Item Name: 205 Skidtube bent detail

DRAWING NO. D2580	TITLE 205 SKIDTUBE ASSEMBLY	REV. E	DART AEROSPACE LTD ENGINEERING ORDER	D.E.O. NO. D2580-E-1	SHEET NO. SHEET 1 OF 1	SCALE NTS
DRAWN <i>UP</i>	CHECKED <i>ASS</i>	MFG. APPR. <i>ER</i>	APPROVED <i>#</i>	DE APPR. <i>#</i>		
DATE 11.12.13	DATE 11.12.13	DATE 11.12.13	DATE 11.12.13	DATE 11.12.13

CHANGE ALL C'BORED WELDED CROSSBOLT SPACERS TO SWAGED SPACERS

SECTION B-B, SECTION F-F, & SECTION I-I ARE AMENDED AS FOLLOWS
FOR ALL HOLES THAT WERE ORIGINALLY C'BORED:

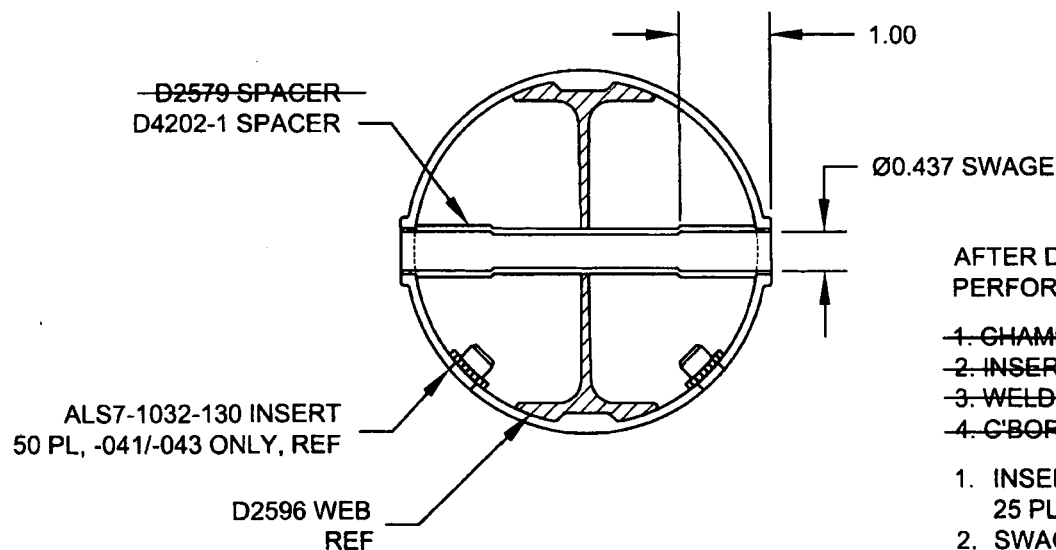
PARTS LIST IS AMENDED AS FOLLOWS:

QTY	QTY	QTY	PART NUMBER	DESCRIPTION
-041	-045	-047		
20	24	25	D2579	CROSS BOLT SPACER

4		* D2579	CROSS BOLT SPACER
20	20	25	D4202-1	SPACER

WELD 4X D2579 SPACERS PER DWG
IN LOCATIONS MARKED "NO C'BORE".
REF SHEET 4 OF DWG.

- ~~1. CHAMFER HOLE 0.050 X 45°~~
- ~~2. INSERT D2579 SPACER (20 PLACES)~~
- ~~3. WELD INTO PLACE AND GRIND FLUSH~~
- ~~4. C'BORE D2579 SPACER TO Ø0.437 X 1.00 DEEP~~

1. INSERT D4202-1 SPACER, 20 PL (-041) OR 20 PL (-045) OR 25 PL (-047)
2. SWAGE TO Ø0.437 X 1.00 DEEP PER QSI 002
3. TRIM / GRIND FLUSH PER QSI 002
